Item
Final Development Plan - Multi-tenant restaurant and Retail Building

Request: Final Development Plan for a 8,040 square foot, 271 indoor and 80 outdoor seat restaurant and a 3,416 square foot retail building within the Alpha B planned development

**City of Bloomington Planning Department
Formal DRC Review Project Narrative
Alpha B Restaurant, Bloomington, MN**

Request: **Final Development Plan for a restaurant and retail building within the Alpha B development located at 8150 26th Avenue South.**

SITE PLAN
C2-1

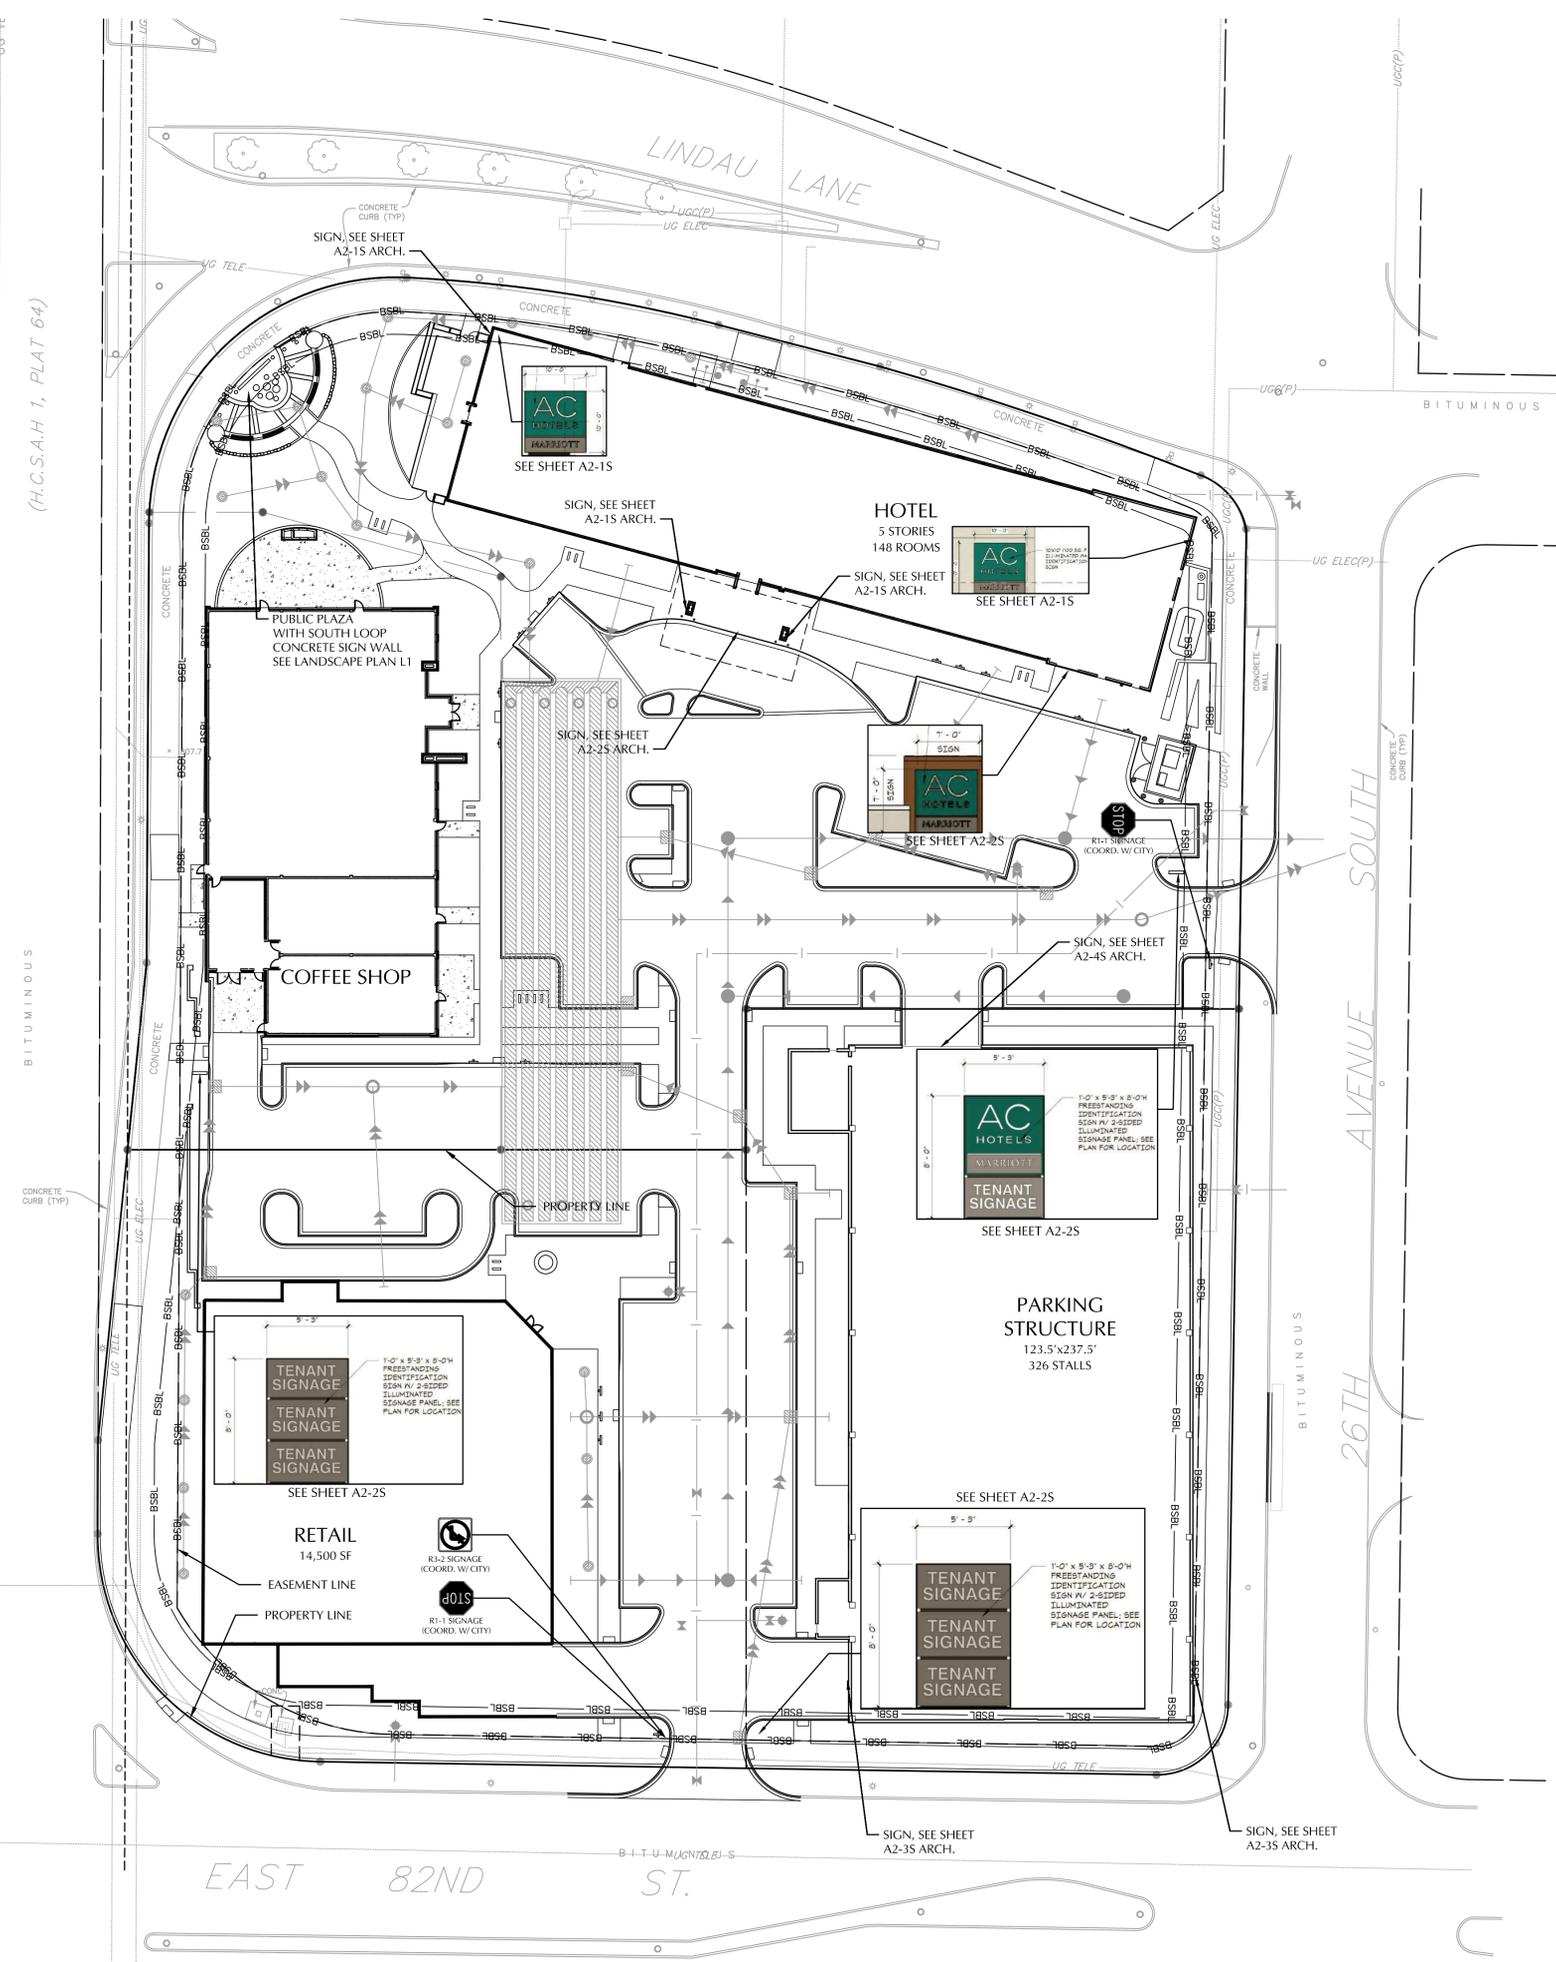
- 1) There is a discrepancy between the number of stalls identified in the project description and what is identified on the plans. Plan sheet C2-1 identifies 421 stalls whereas the project description identifies 425. The four stalls makes a difference whether or not an additional deviation is needed. A deviation for 3 parking stalls has already been approved.

DETAIL SHEET
C8-2

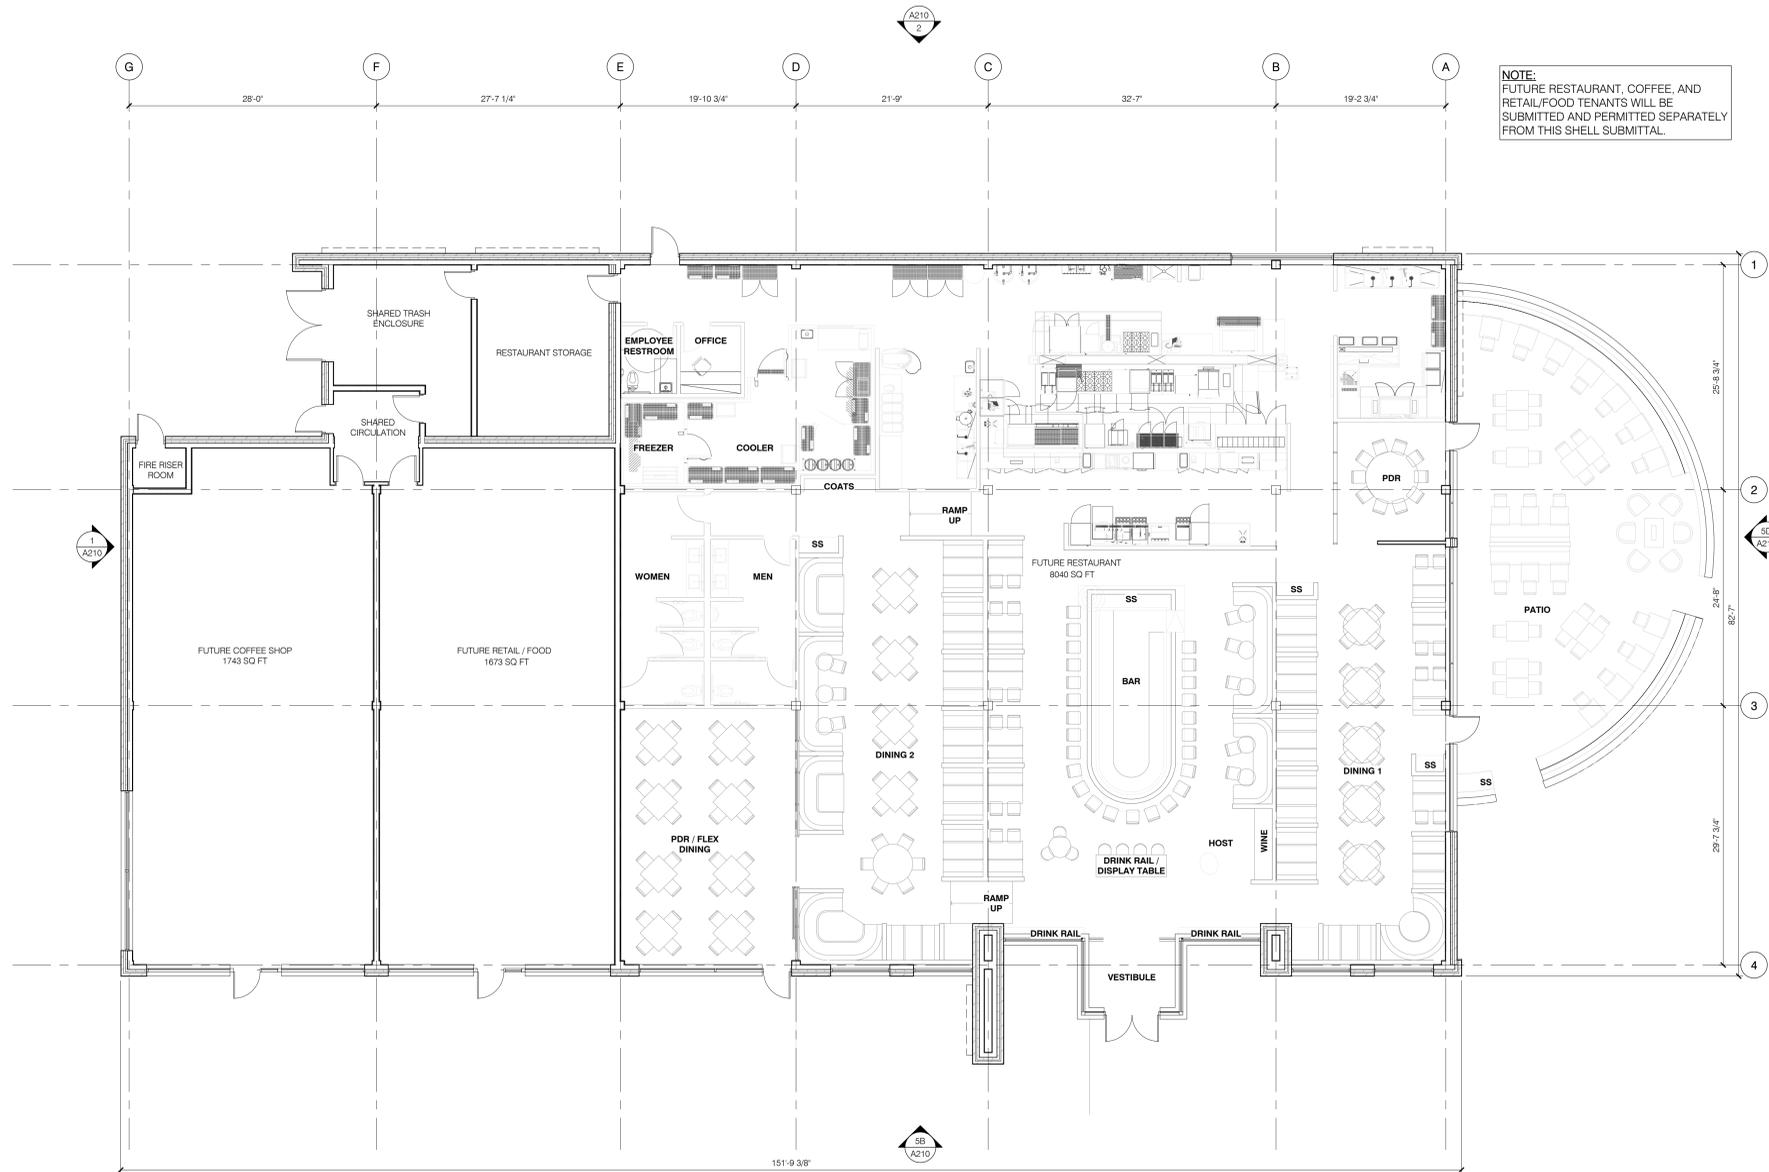
4) Verify that the details are legible at full size. On sheet 8-2 there is a vast difference in size between the wheelchair symbol and the pedestrian curb ramp. Are they all readable?

WEST ELEVATION

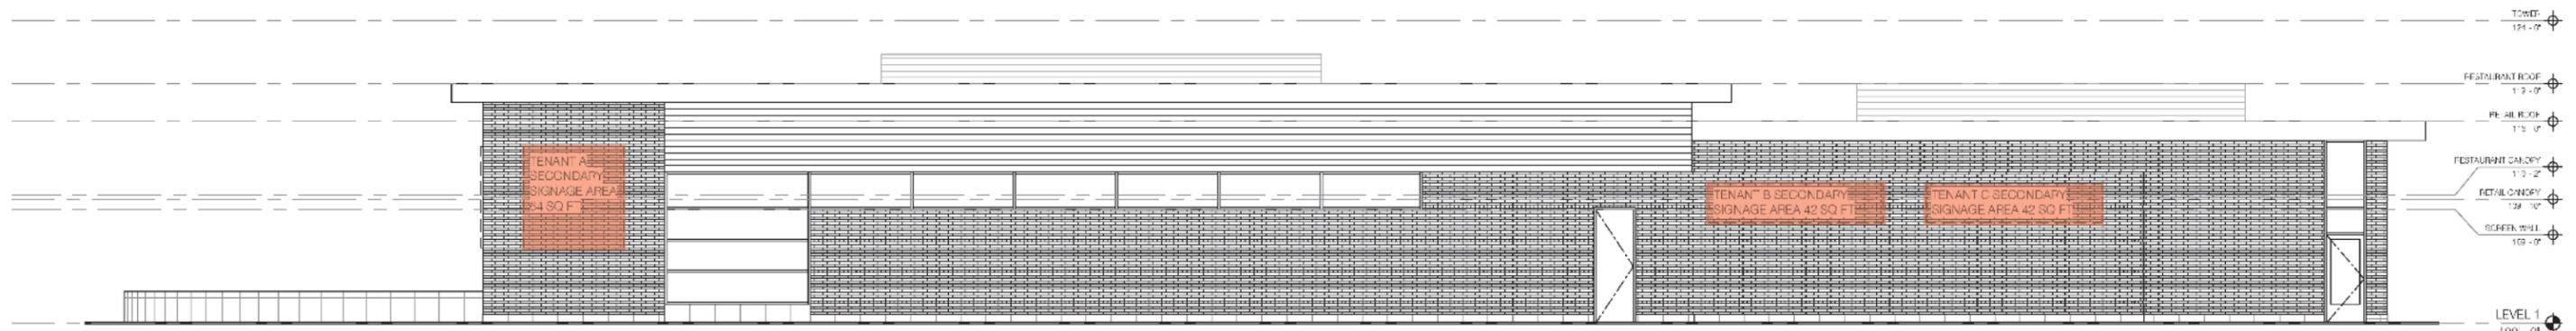
- There are complications they need to be mindful of. Ideally, there could be some revisions to the west elevation before the Planning Commission reviews this.
